DOCUMENT 00 90 00
ADDENDUM

ADDENDUM NO. [2] **Date: February 26, 2020**

RE: **WESTERN TECHNICAL COLLEGE**
APPRENTICESHIP CENTER REMODEL
2860 21ST PLACE SOUTH
LA CROSSE, WISCONSIN 54601
HSR PROJECT NO. 19021

FROM: HSR Associates, Inc
100 Milwaukee Street
La Crosse, WI 54603
(608) 784-1830

1 PLUMBING FLOOR PLAN – NEW WORK
1/8" = 1'-0"

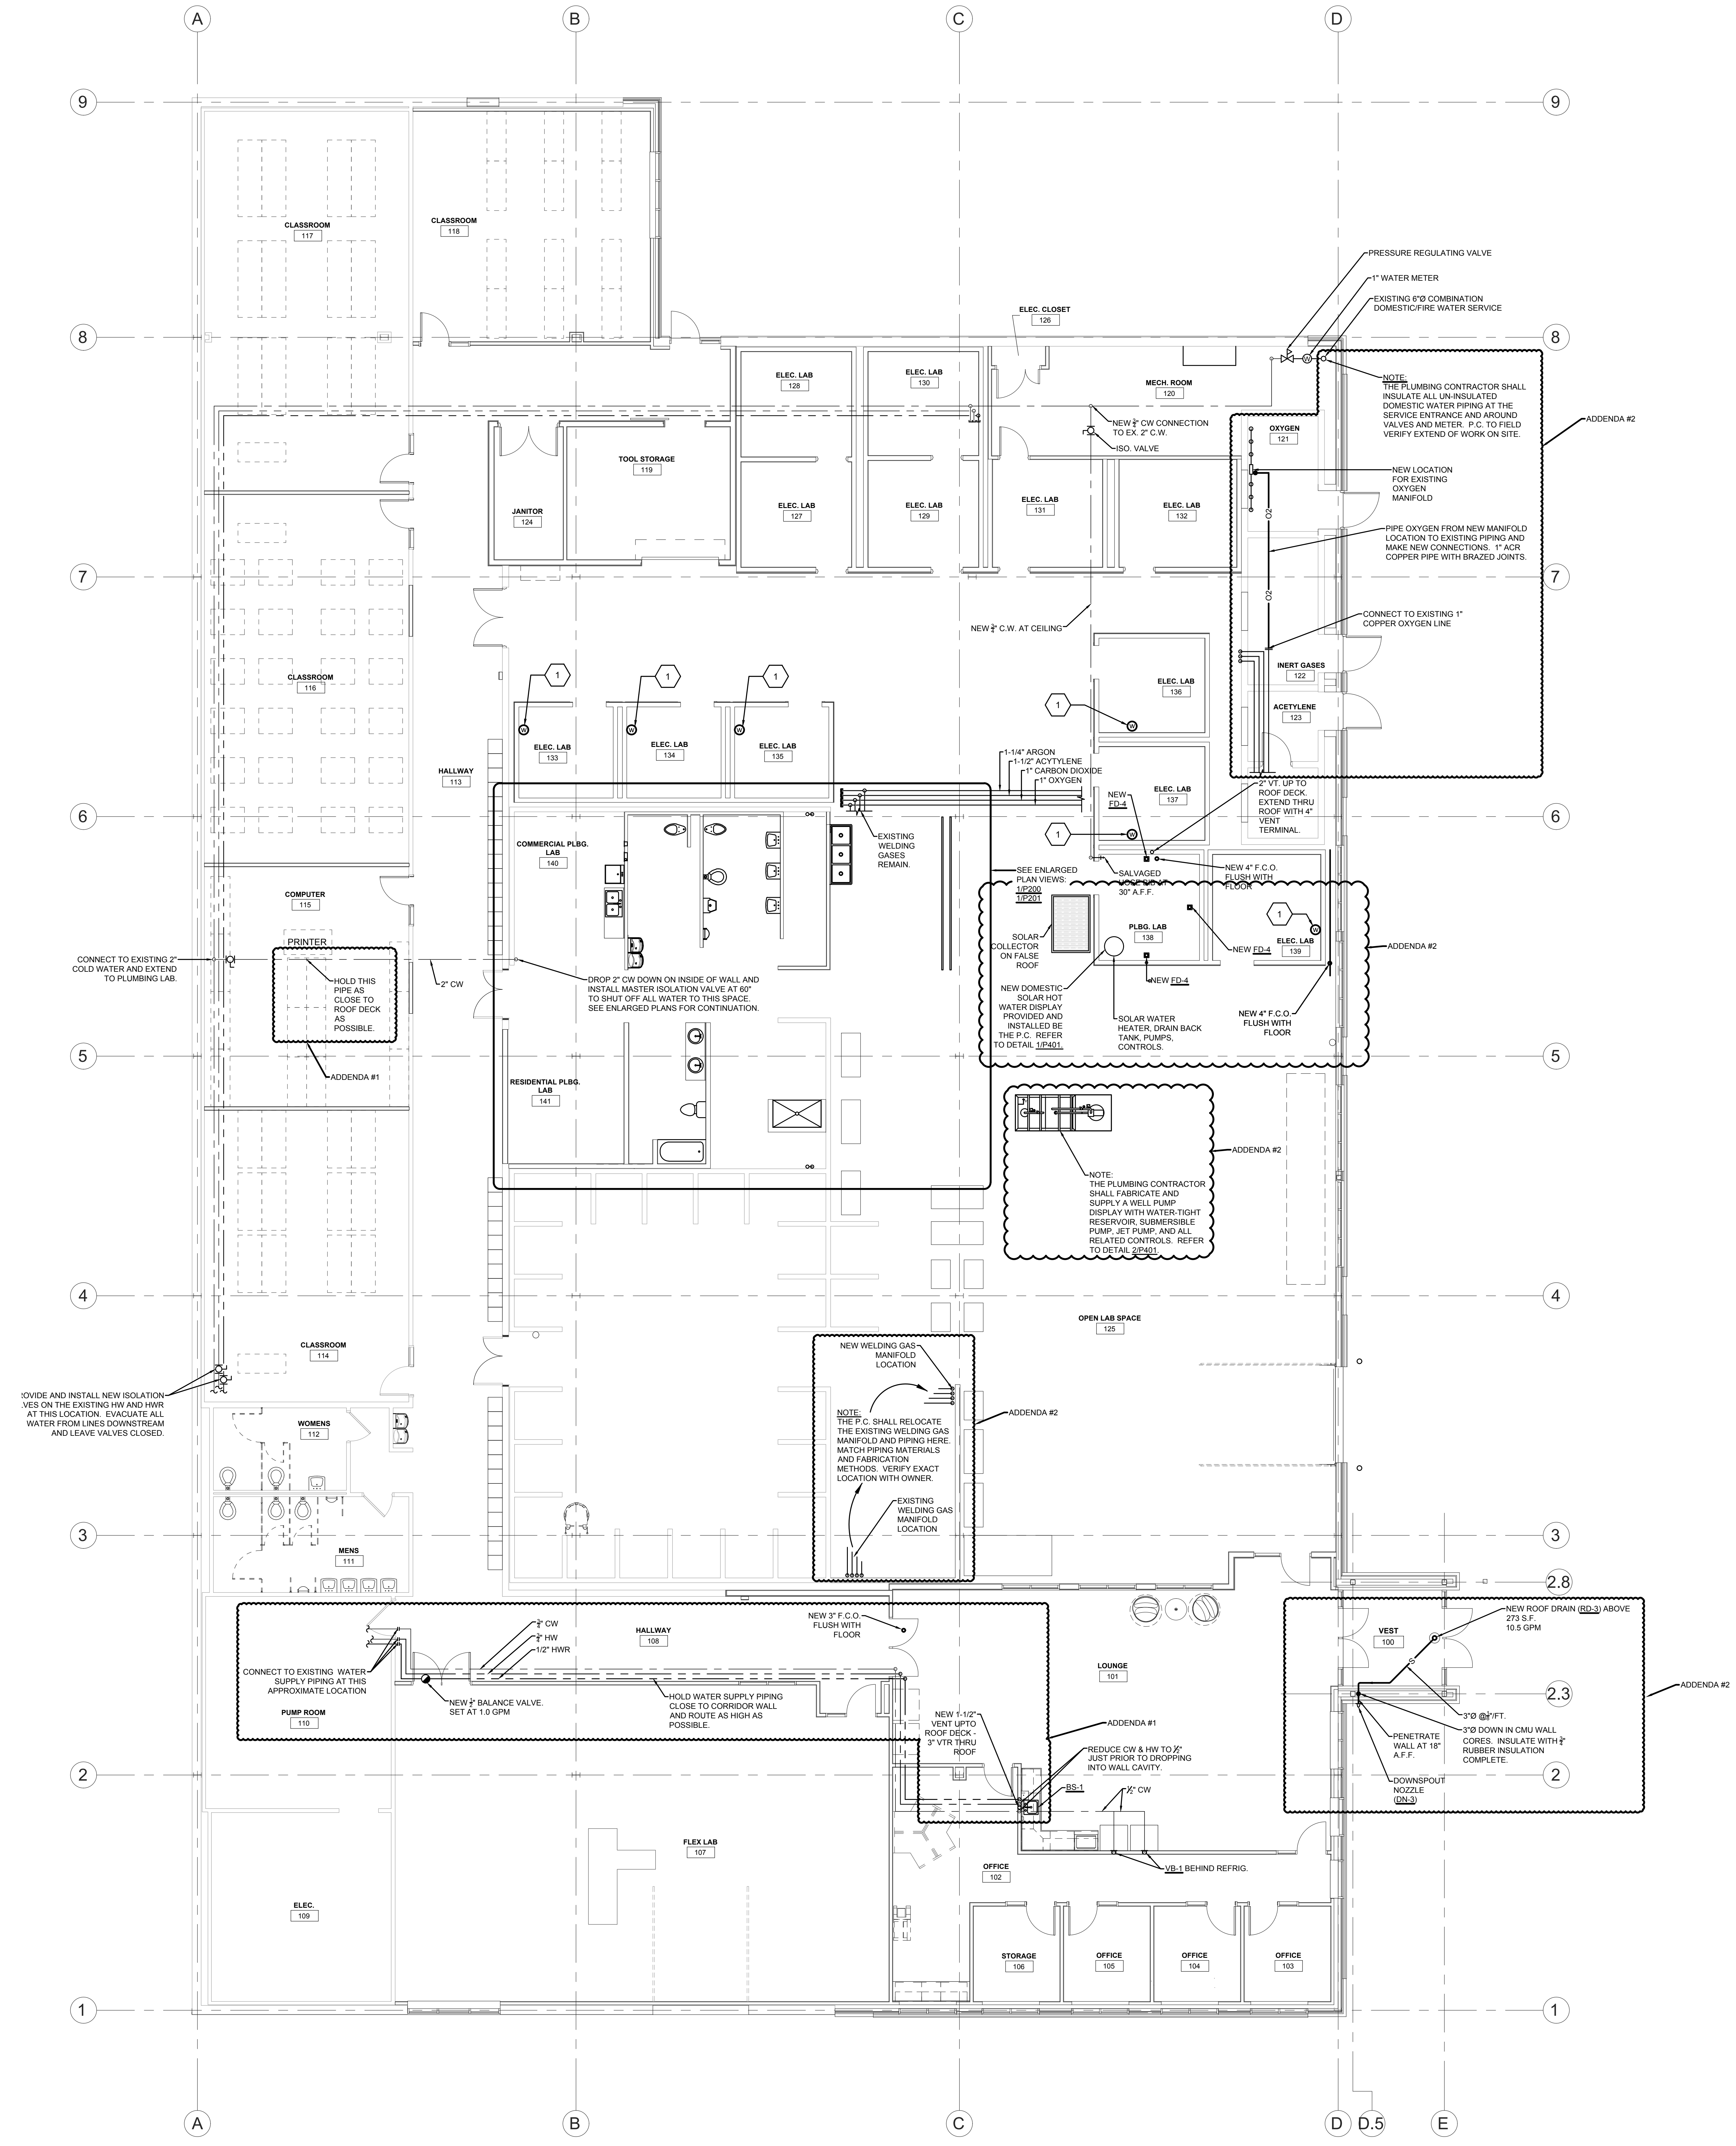
OPEN LAB SPACE
125
CLASSROOM
114
NEW WELDING GAS MANIFOLD LOCATION
ADDENDA #2
NOTE:
THE P.C. SHALL RELOCATE THE EXISTING WELDING GAS MANIFOLD AND PIPING HERE. MATCH PIPING MATERIALS AND FABRICATION METHODS. VERIFY EXACT LOCATION WITH OWNER.
EXISTING WELDING GAS MANIFOLD LOCATION
OVIDE AND INSTALL NEW ISOLATION VES ON THE EXISTING HW AND HWR AT THIS LOCATION. EVACUATE ALL WATER FROM LINES DOWNSTREAM AND LEAVE VALVES CLOSED.
WOMENS
112
MENS
111
¾" CW
¾" HW
1/2" HWR
HALLWAY
108
NEW 3" F.C.O. FLUSH WITH FLOOR
CONNECT TO EXISTING WATER SUPPLY PIPING AT THIS APPROXIMATE LOCATION
PUMP ROOM
110
NEW ½" BALANCE VALVE. SET AT 1.0 GPM
HOLD WATER SUPPLY PIPING CLOSE TO CORRIDOR WALL AND ROUTE AS HIGH AS POSSIBLE.
LOUNGE
101
NEW 1-1/2" VENT UPTO ROOF DECK - 3" VTR THRU ROOF
ADDENDA #1
REDUCE CW & HW TO ½" JUST PRIOR TO DROPPING INTO WALL CAVITY.
BS-1
½" CW
VB-1 BEHIND REFRIG.
VEST
100
NEW ROOF DRAIN (RD-3) ABOVE 273 S.F. 10.5 GPM
S
3"Ø @⅛"/FT.
